Subject: Issuance of Amendment No. 18 to Facility Operating License NPF-12 Virgil C. Summer Nuclear Station, Unit No. 1

VIRGIL C. SUMMER NUCLEAR STATION, UNIT NO. 1

AMENDMENT TO FACILITY OPERATING LICENSE

Amendment No. 18
License No. NPF-12

FIGURE 6.2.1
SOUTH CAROLINA ELECTRIC AND GAS COMPANY
VIRGIL C. SUMMER NUCLEAR STATION
OFFSITE ORGANIZATION

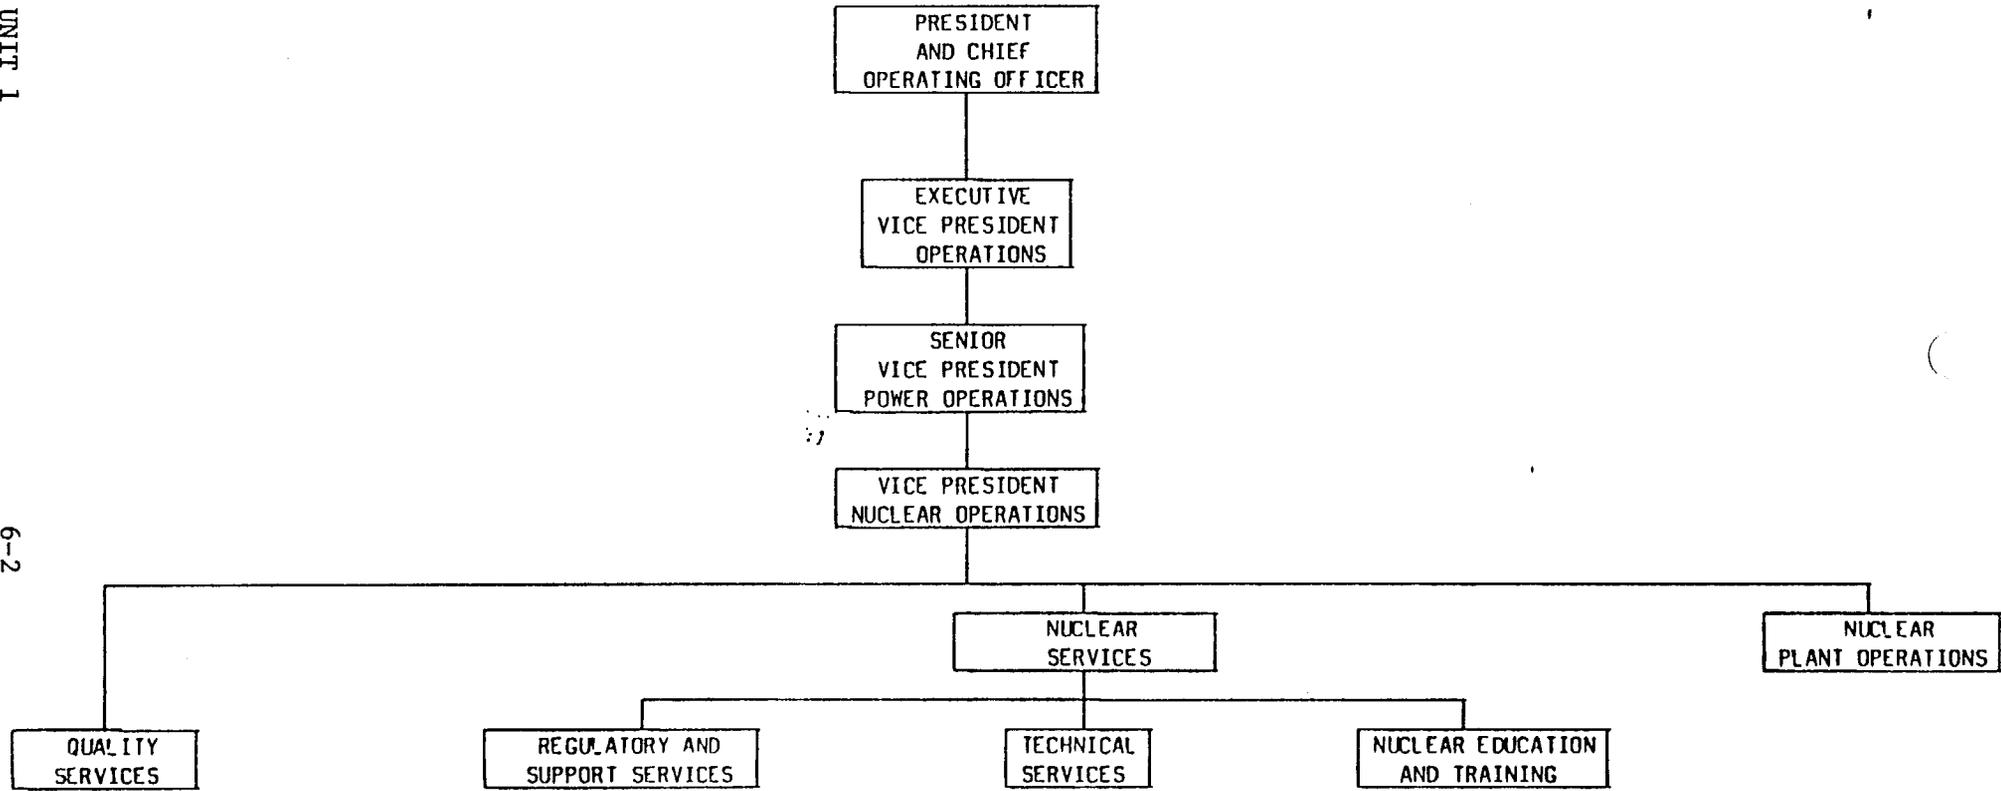
SCE&G has instituted changes to centralize the management of their nuclear departments other than Quality Assurance and Plant Operation and to establish a direct communications channel to the Vice President, Nuclear Operations from quality assurance and plant operations. The revised organization, shown in Technical Specification Figure 6.2-1, establishes the functional entity of Quality Services (responsible for operational quality assurance) which reports directly to the Vice President, Nuclear Operations; establishes the new position of Director, Nuclear Services that centralizes the management of Regulatory and Administrative Services, Technical Services, Support Services, and Nuclear Education and Training into that position; and provides for the Director, Nuclear Plant Operations to report directly to the Vice President, Nuclear Operations. The reporting chain of the Nuclear Safety Review Committee has been changed from the Senior Vice President, Power Operations to the Vice President, Nuclear Operations.

We have reviewed these changes and find them acceptable as they meet the acceptance criteria of Section 13.1.1 and 13.4 of the Standard Review Plan, NUREG-0800.

FIGURE 6.2-2
 VIRGIL C. SUMMER NUCLEAR STATION
 FUNCTIONAL ORGANIZATION

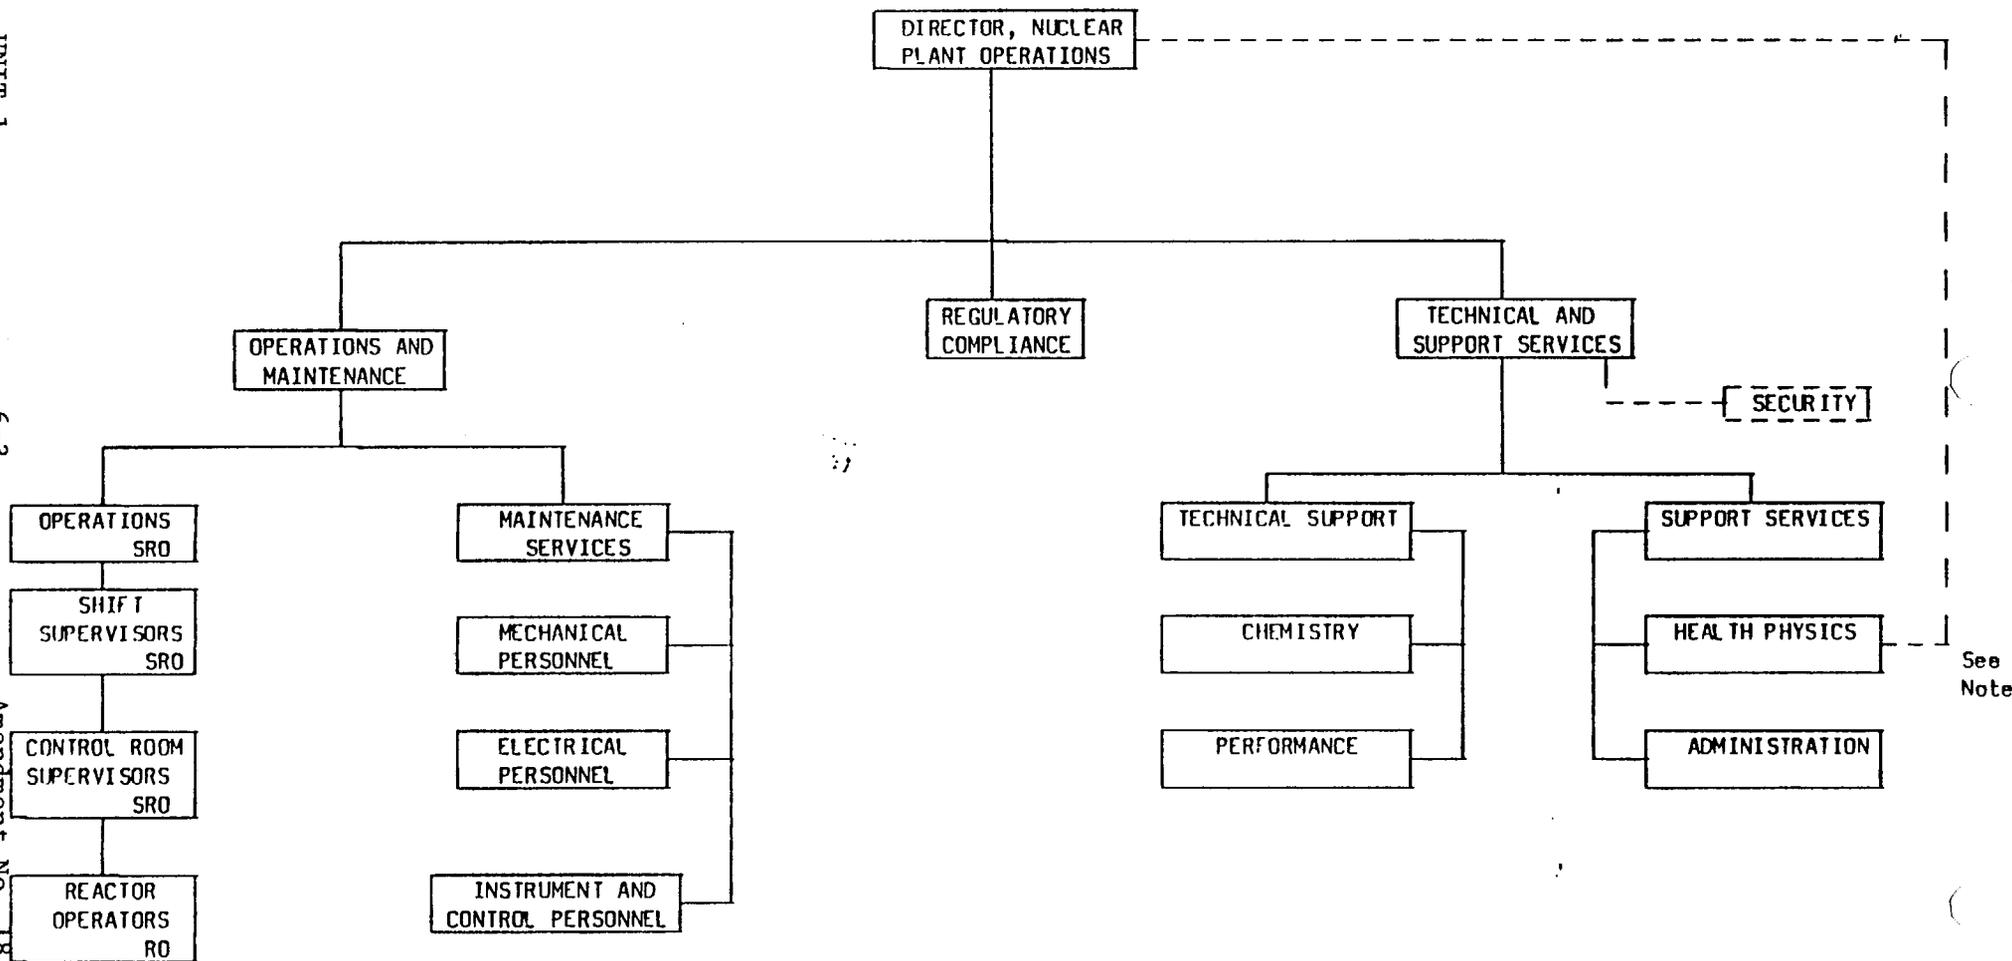
SCE&G has instituted changes under the Director, Nuclear Plant Operations (new title) to centralize plant activities under the new positions of Deputy Director, Operations and Maintenance, and Group Manager, Technical and Support Services. Additionally the position of Associate Manager, Regulatory Compliance has been established. These changes are shown in Technical Specification Figure 6.2.-2. With the creation of these new positions, the position of Deputy Manager, Summer Nuclear Plant has been deleted.

We have reviewed these changes and found them acceptable as they meet the requirements of Section 13.1.2 of the Standard Review Plan, NUREG-0800, and the requirements of Section 3.4 of ANSI-N18.7, 1976, "Administrative Controls and Quality Assurance for the Operational Phase of Nuclear Power Plants", as endorsed by Regulatory Guide 1.33.
